ADDENDUM NO. 4

May 6, 2025

This Addendum contains changes to the requirements of the Contract Documents and Specifications. Such changes are to be incorporated into the Construction Documents and shall apply to the work with the same meaning and force as if they had been included in the original document. Wherever this Addendum modifies a portion of a paragraph of the specifications or a portion of any Drawing, the remainder of the Paragraph or Drawing shall remain in force.

**RENOVATE 2ND - 5TH FLOOR
AT KING-SHAW HALL**

A-201R

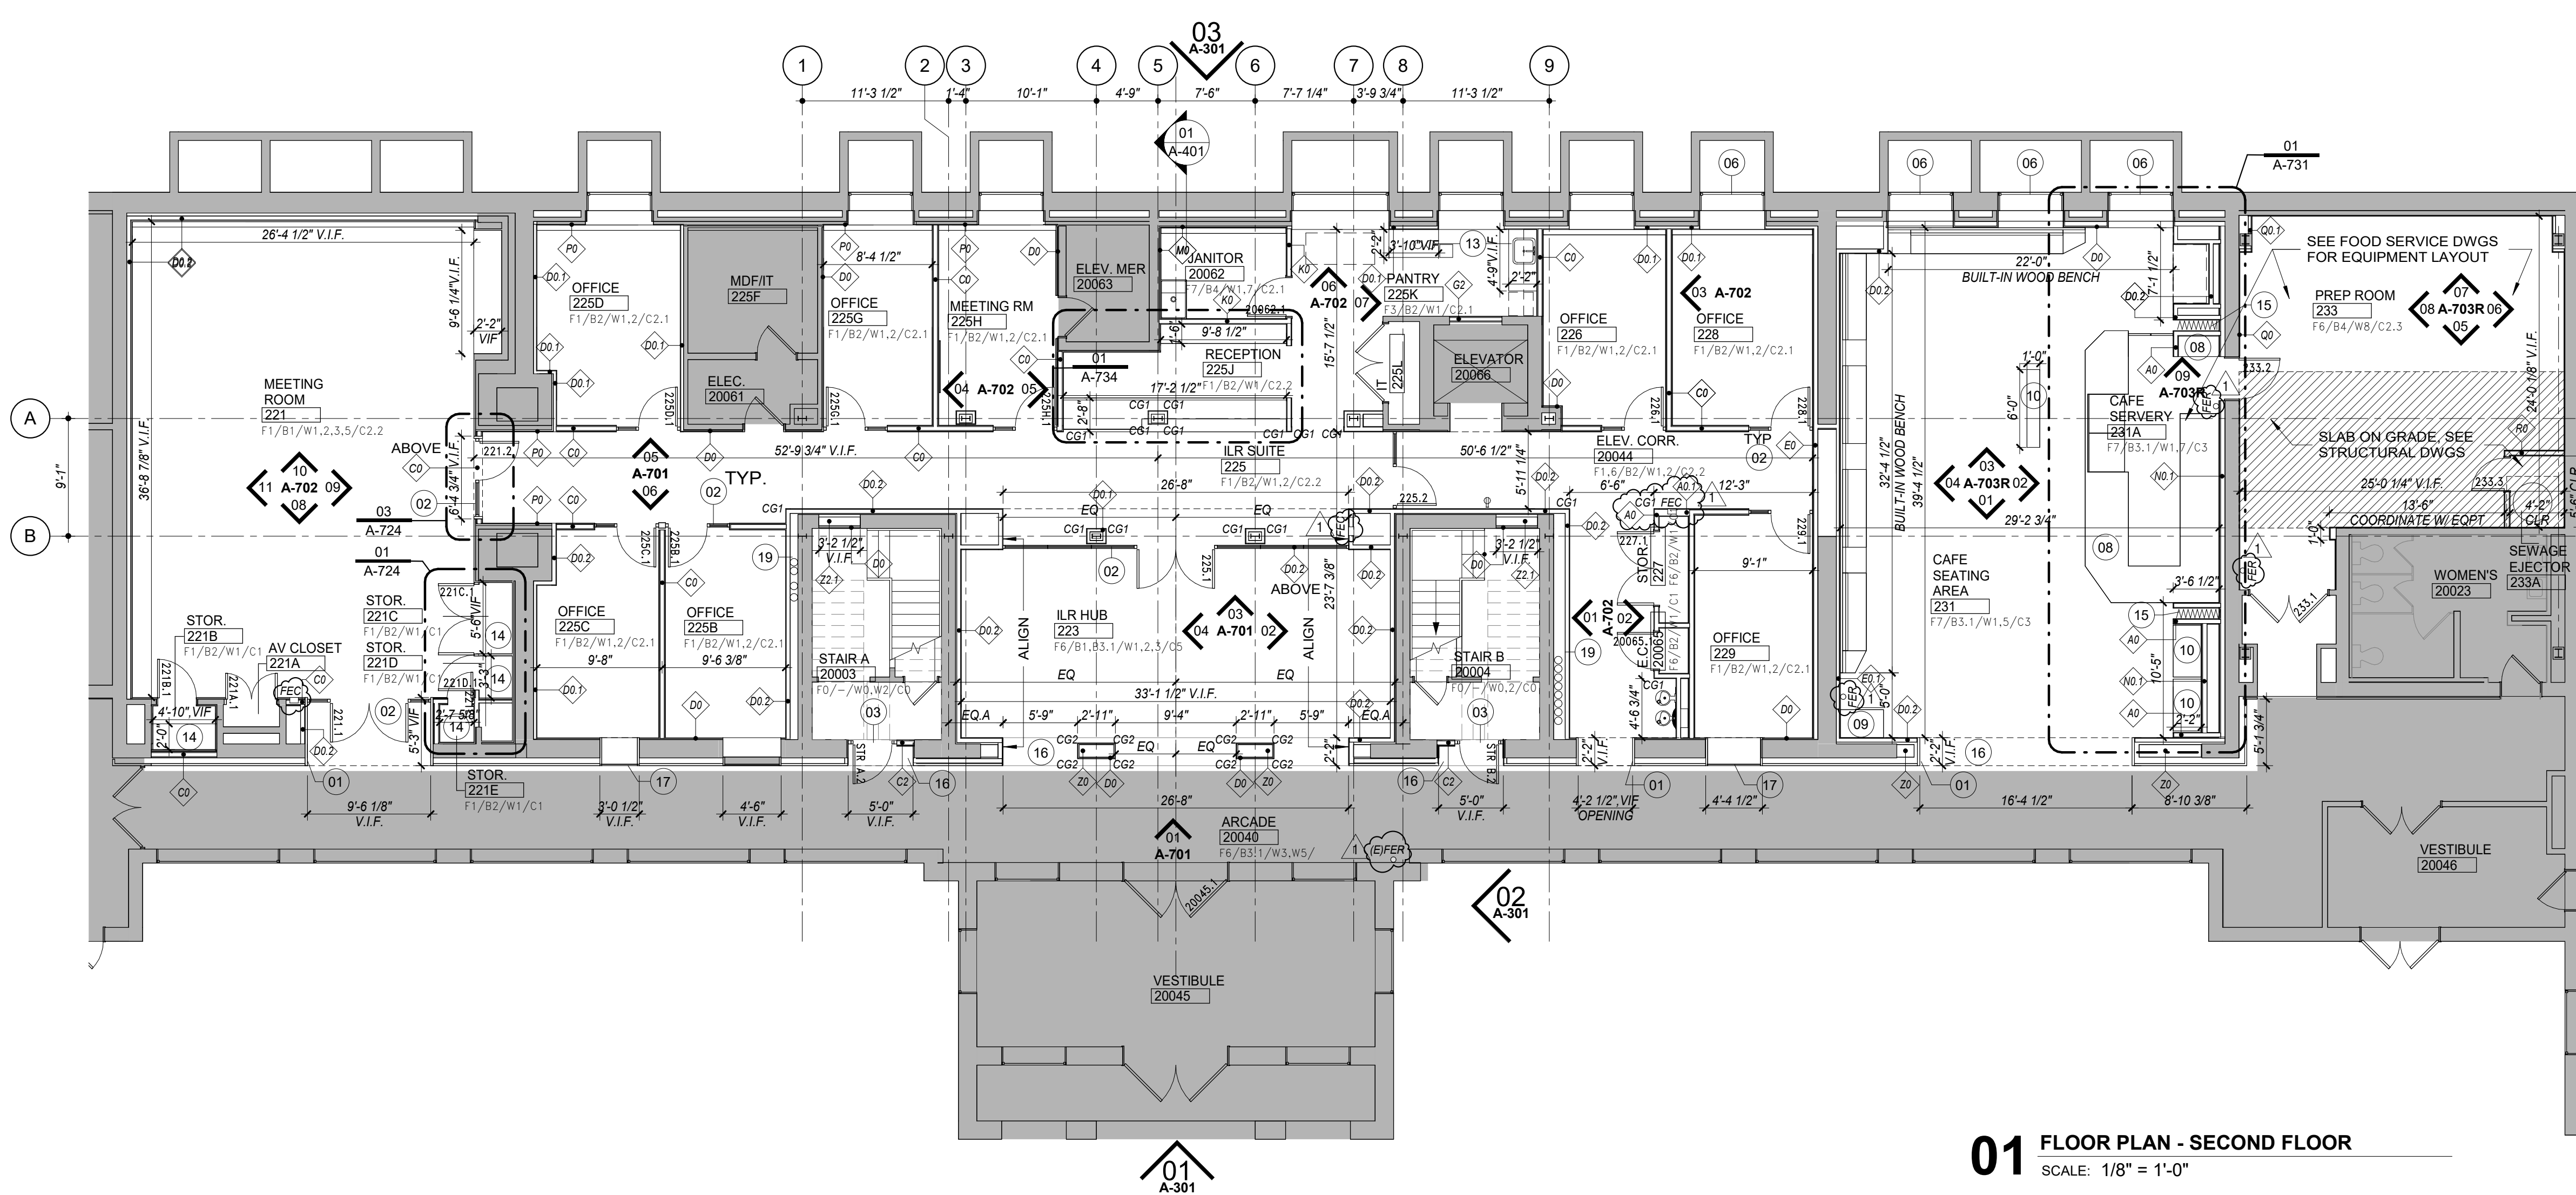
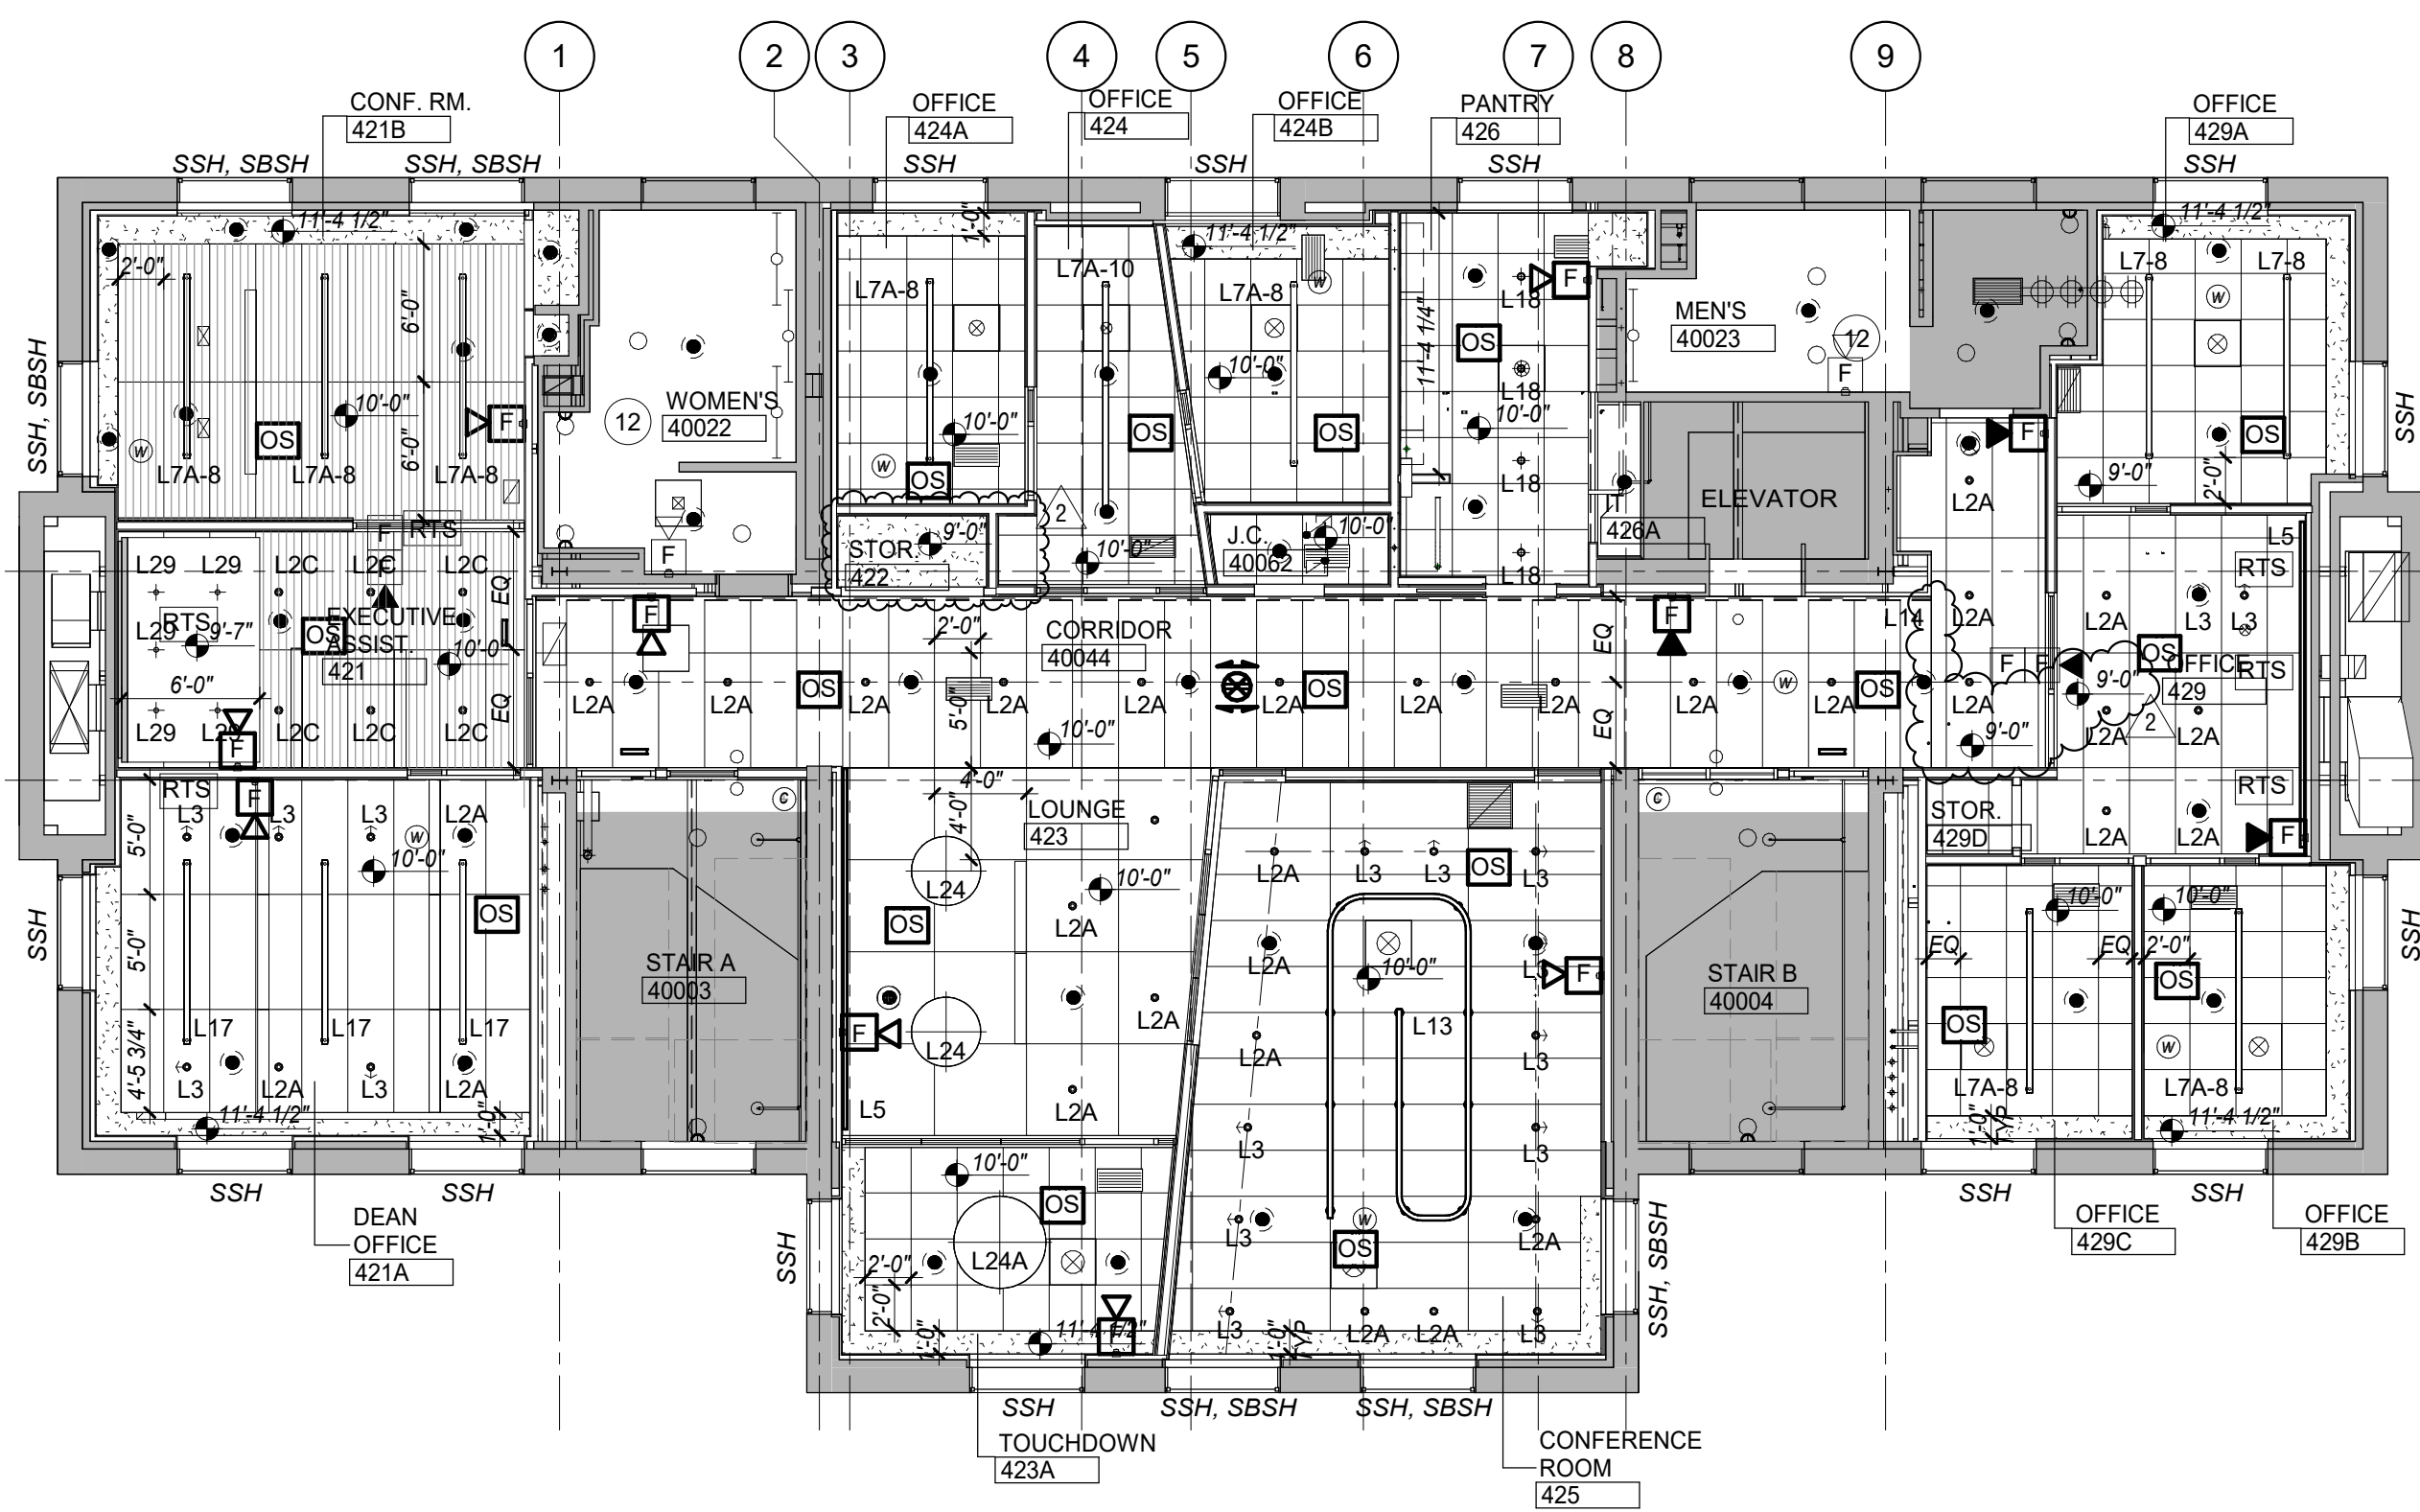
RFI/ Response Index	Page/ Dwg./Spec./Rep. Number	Section/ Paragraph/Topic	RFI	Design Team Response
26	104416	Fire Extinguisher Cabinets	Could not find any FEC shown on the drawings. There is a specification. Please clarify.	See Addendum No. 4 and revised Floor Plans locating FECs.
27	A-750	Signage	Drawing A-750 calls for vinyl signage at details 2, 3 and 5. Please update specification 101400 Signage with information regarding the vinyl signage. Also, these are called out at various interior elevations but the notes tell us to reference A-750. Sometimes it is quite clear what sign is desired but other times it is not. Can the interior elevation notes be updated to add which specific detail on A-750? This will help our signage vendors to provide the most accurate pricing possible.	Signage scope to be confirmed with Owner. See notes at detail 05 on Drawing A-750 for current scope information.
28	A-740	OFCI Items	Please reference A-740. The finish schedule calls for the Composite Paneling that is specified in section 068300 as OFCI. The specification does not indicate that this product is OFCI. Please clarify who is to be providing this product. Same question for items UF1 & UF2. All of the fabric items within specification 098413 Acoustic Panel Fabric are listed as OFCI as well. Please confirm who is to be providing these products.	Composite Paneling, UF1, UF2, and acoustic panel fabrics are Owner-Furnished, Contractor-Installed.
